ZONING CHANGE REVIEW SHEET

CASE: C814-89-0003.02 – 305 S. Congress PUD DISTRICT: 9

ADDRESS: 305 S. Congress Avenue

Conceptual Open Space Map

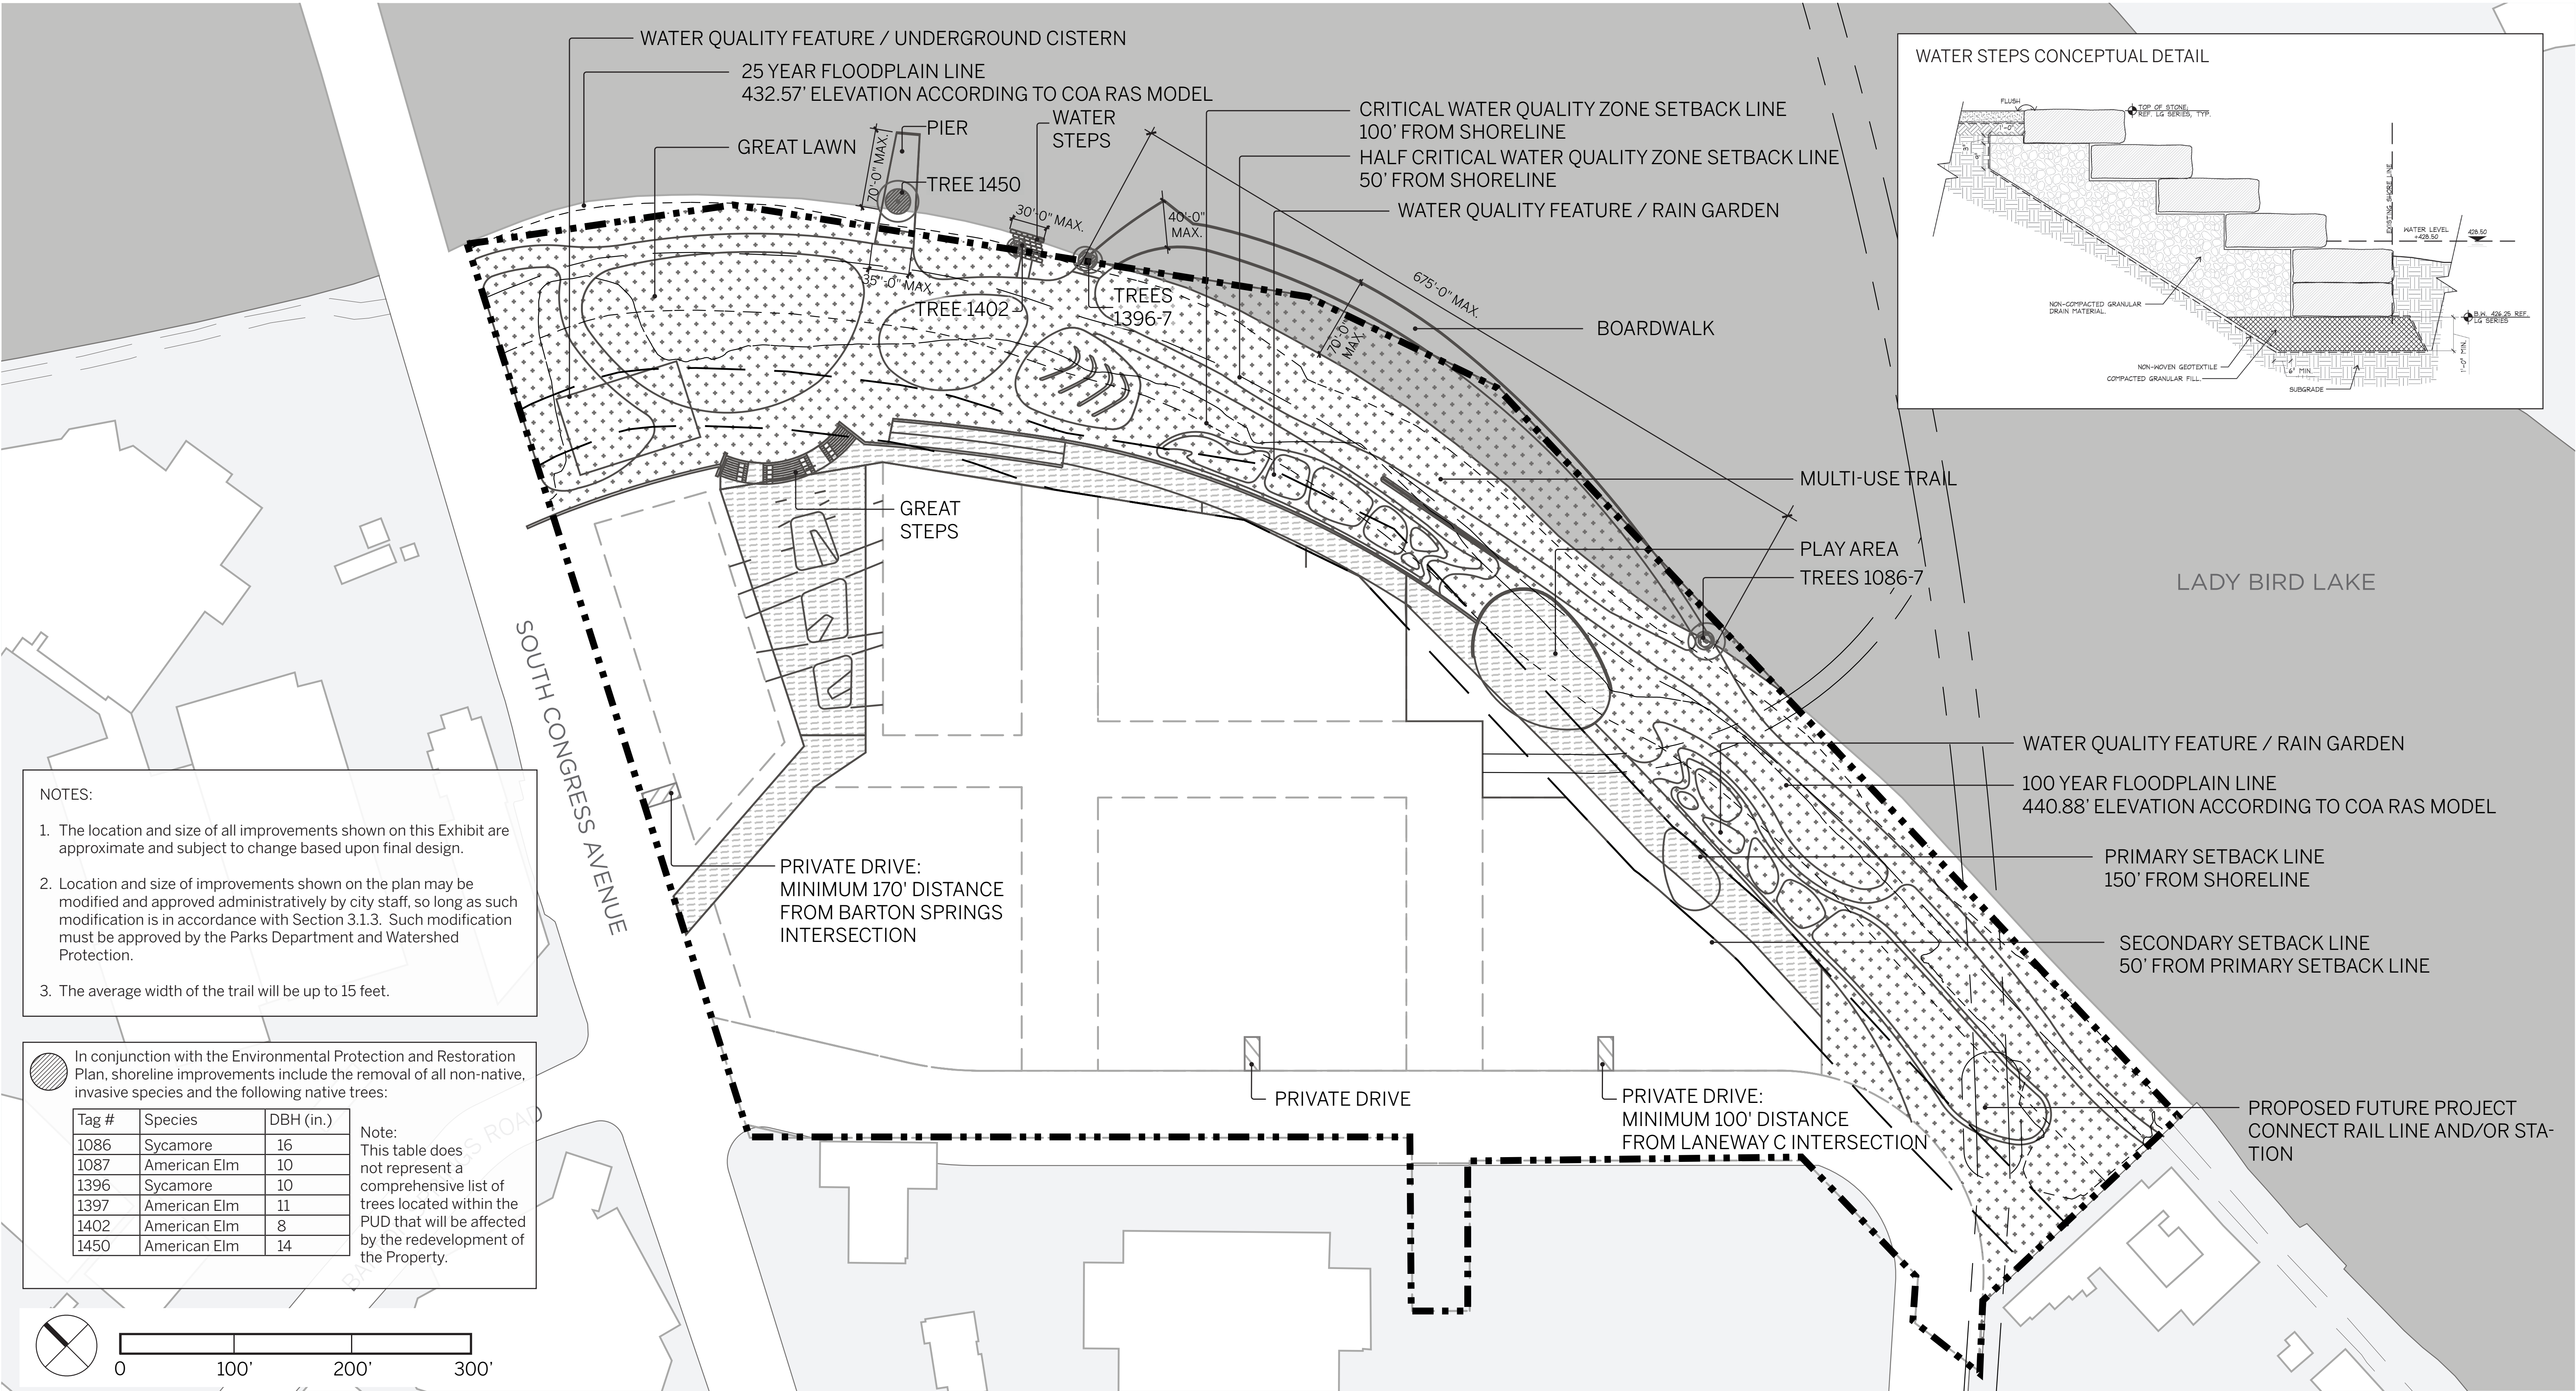
- a. Recommended by staff.
- **Section 25-2-1176(A)(4) (*Site Development Regulations for Docks, Marinas and Other Lakefront Uses*) is modified to allow for construction of the elements and dimensions shown on the Conceptual Open Space Map. The boardwalk is not to exceed 675 linear feet of shoreline frontage.**

WG Amendment #14

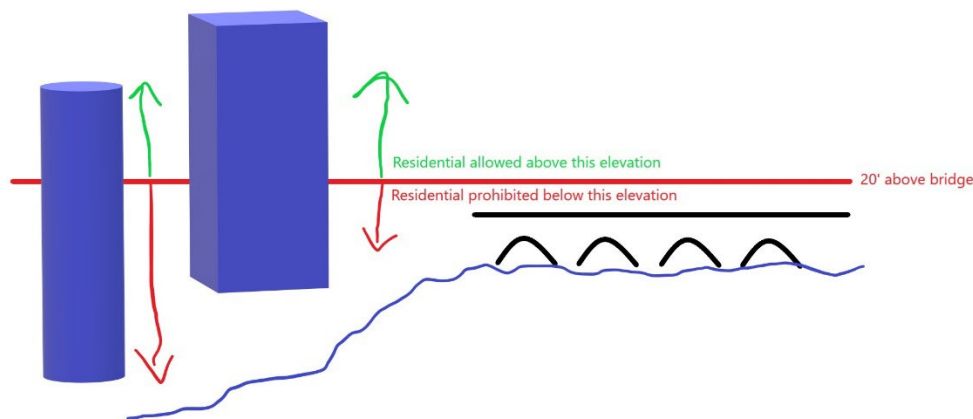
- 5) Please provide a schematic to explain this setback amendment. It is difficult to visualize the phrase “below 20’ above the elevation of the Congress Ave. bridge pavement.”

Commissioner Cox, Working Group Response:
